Lean Above Idle RPM – 1990 Mariner/Mercury 135

MODELS

1990	Mariner 135	S/N 0C221500 thru 0C284070
1990	Mercury 135	S/N 0C221500 thru 0C284070

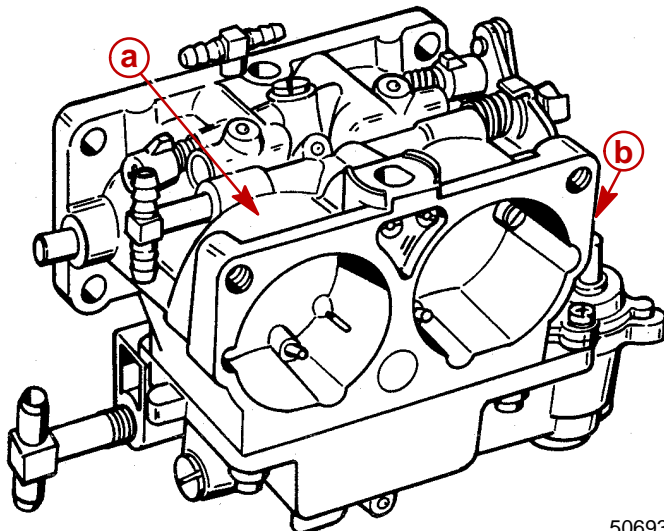
Early 1990 production 135 outboards with WMH-5 carburetors may hesitate when accelerated from idle and/or drop RPM or quit running when operated between 1000 and 1500 RPM. The cause may be a lean fuel condition and occurs more frequently on light/fast boats. Check the basics first – carburetor adjustment, timing/carburetor synchronization, ignition and fuel system. Next, try to correct by turning all six idle mixture screws counterclockwise (richer) the same amount. This will richen the idle fuel mixture and may correct the lean condition above idle RPM. If this does not correct the hesitation, replace all three carburetors and exhaust extension as listed.

- a** - Carburetor Model (WMH)
- b** - Carburetor Number (8-1, 8-2, etc.)

50693

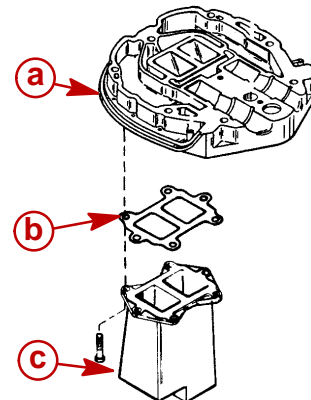
Replace exhaust extension.

- a** - Drive Shaft Housing Plate
- b** - Gasket
- c** - Exhaust Extension

IDENTIFY REPAIR:

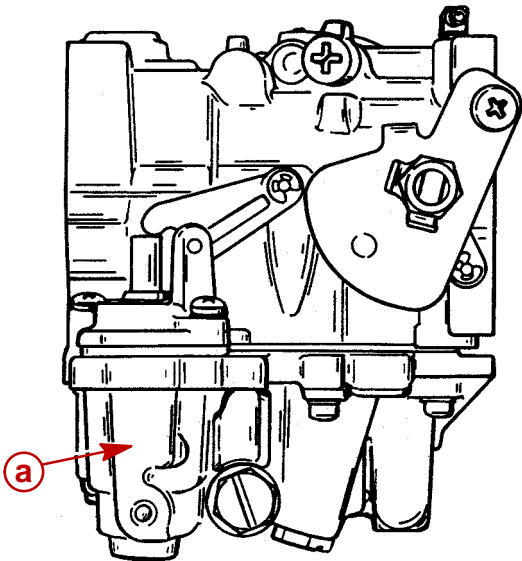
Scribe an "X" on the side of each carburetor casting by accelerator pump.

a - Identify with "X"
